**Franklin County Board of Commissioners Rezoning Hearing**  
**Franklin County Courthouse**  
**373 South High Street – 26<sup>th</sup> Floor**  
**Columbus, OH 43215**

**Tuesday, July 10, 2018**  
**10:00 a.m.**

**MINUTES OF THE  
FRANKLIN COUNTY BOARD OF COMMISSIONERS  
REZONING HEARING**

### **Case: ZON-17-04 (Modification)**

**OLENTANGY VALLEY CENTER**  
**PRELIMINARY DEVELOPMENT PLAN**  
FOR  
**CONTINENTAL REAL ESTATE**  
**PRELIMINARY SITE PLAN**

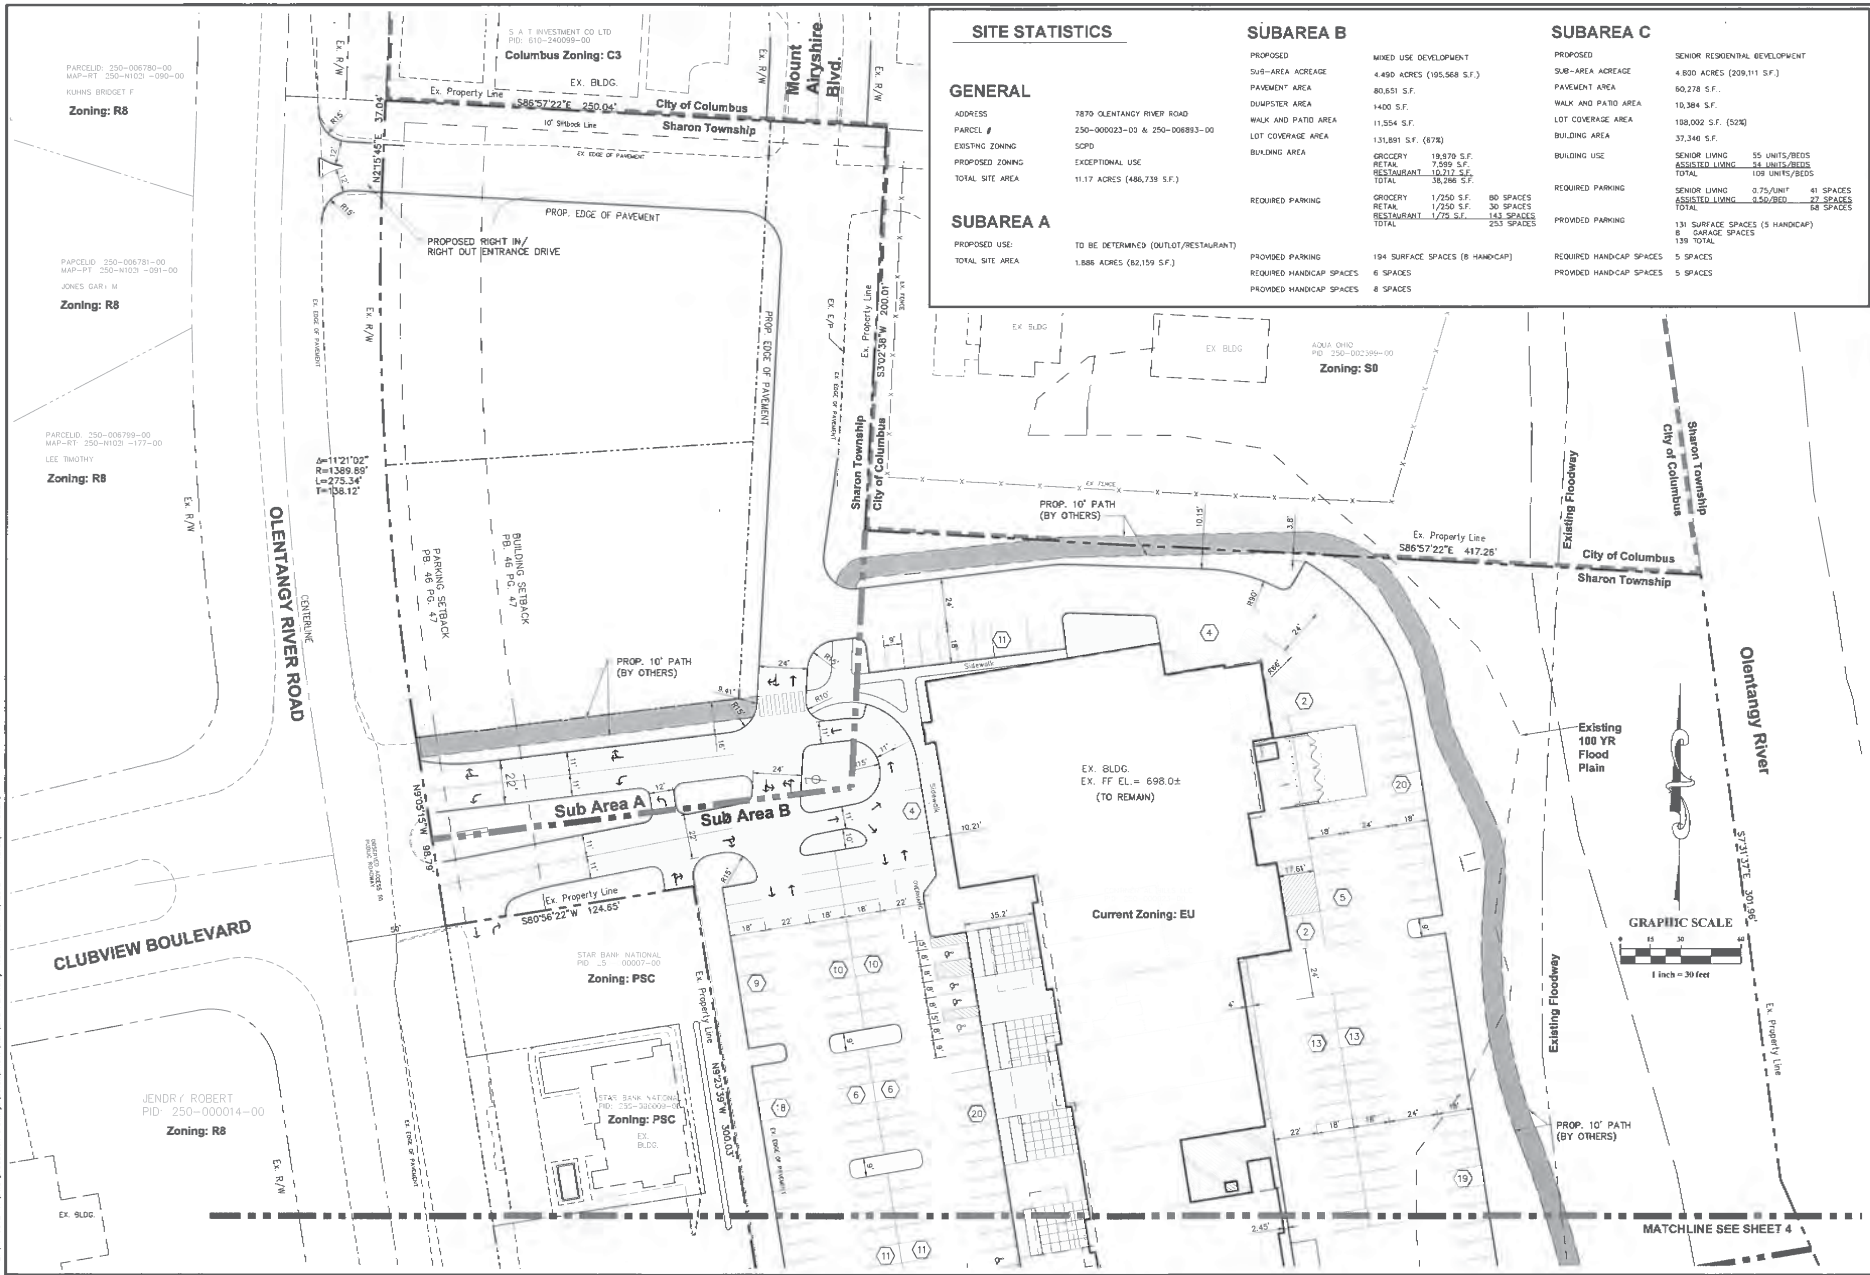
- Retain the entrance drive design at Clubview Boulevard.
- Remove a small curb island in front of the Hills Market.
- Demolish a portion of the existing building structure located at the southeast corner of the Rusty Bucket space. This area has been replaced with a drive aisle, parking and a proposed dumpster enclosure for the Rusty Bucket space.
- Replace the drive aisle between the existing retail building and the proposed assisted living/elderly housing structure with a plaza. The plaza will include green space and a pedestrian connection to the future bike path.
- Add parking spaces and landscape islands in front of the plaza area.

- The assisted living/elderly housing architectural elements have been modified including: windows, pillars, patios, rooftop screening and entryways.
- The assisted living units will increase from 50 to 54 units, and the elderly units will increase from 50 to 55 units.
- Parking spaces and curb islands have been adjusted.
- Relocate the monument sign that is centrally located at the south drive entrance to the center of the new median.
- Reduced parking garage bays for the assisted living/elderly housing from six (6) four (4).

Continental Real Estate has proposed a few minor changes to the Olentangy Valley Center preliminary development plan from the original rezoning efforts for the project from last year. A new development package has been submitted to the County for review and consideration. We do think that the changes made have been very positive changes that will benefit the project and the community. We hope that the County agrees with our position. Below is a list of identified changes from the original plan to the latest version submitted to the County's development office:

- There is a slight modification of the service road on the east side of Subarea A. A field topographic survey has confirmed the location of the existing roadway edge. The plan for Subarea A is simply to keep the drive as it currently exists.

- There are slight modifications to the entrance at Clubview Boulevard. Again with an accurate topographic survey, our intent is to keep the entrance drive apron as it exists today. There may be a mill and overlay in this area to update the pavement but no curb changes in the public ROW are now anticipated.

- The original plan identified a drive aisle between the existing retail building and the proposed assisted living/elderly housing structure. This area has been modified to be a plaza area that will

- create more green space, a better outdoor area for the Rusty Bucket restaurant and also provide a pedestrian connection to the future bike path to be constructed by the City of Columbus along the Olentangy River.
- Minor island adjustments have been made to the parking lot in front of the new plaza area to remove the drive connection, and add more parking and landscape islands.

- The assisted living/elderly housing structure has been modified with further architectural efforts. The building elevations are in the spirit of the original plans. This building was originally planned to have 50 assisted living units and 50 senior housing units. The new plan has proposed 54 assisted living units and 55 elderly housing units.

- The main entrance has been modified to allow better function and flow of traffic for the porte cochere area for drop off and pick up of guests or tenants. Minor parking modifications have been made with the new entrance modifications.

- In the rear (east side) of the building structure, the garage structures were originally shown as six (6) bay garages; the new plan has each with four (4) bays.

Staff believes that the proposed modifications keep with the intent of the previously approved rezoning and that it will adversely affect with the general health, safety or welfare of the public or be in conflict with the development standards of the Exceptional Use district. Staff further believes that the request encourages appropriate use and development of the land affected and the overall development of the surrounding area.

1. The applicant shall apply for and receive approval of a Certificate of Zoning Compliance from the Franklin County Economic Development and Planning Department prior to any development or change in use on the site.
2. The applicant shall apply for and receive approval of building permits from the State of Ohio for any proposed construction.
3. The applicant must revise the development text to explicitly prohibit the use of digital and changeable copy signs in all subareas.
4. The applicant must provide a copy of an approved easement for a bike path, to be approved by the Columbus Recreation and Parks Department, at the time of submitting a Certificate of Zoning Compliance. The development plan submitted with the Certificate of Zoning Compliance may be

amended to allow for a parking space reduction of up to eight (8) spaces in the northern part of Subarea B to facilitate the placement of the bike path.

5. The applicant must install 16 bicycle parking spaces in Subarea B that meet the design standards as described in Section 670.0814 of the Franklin County Zoning Resolution.
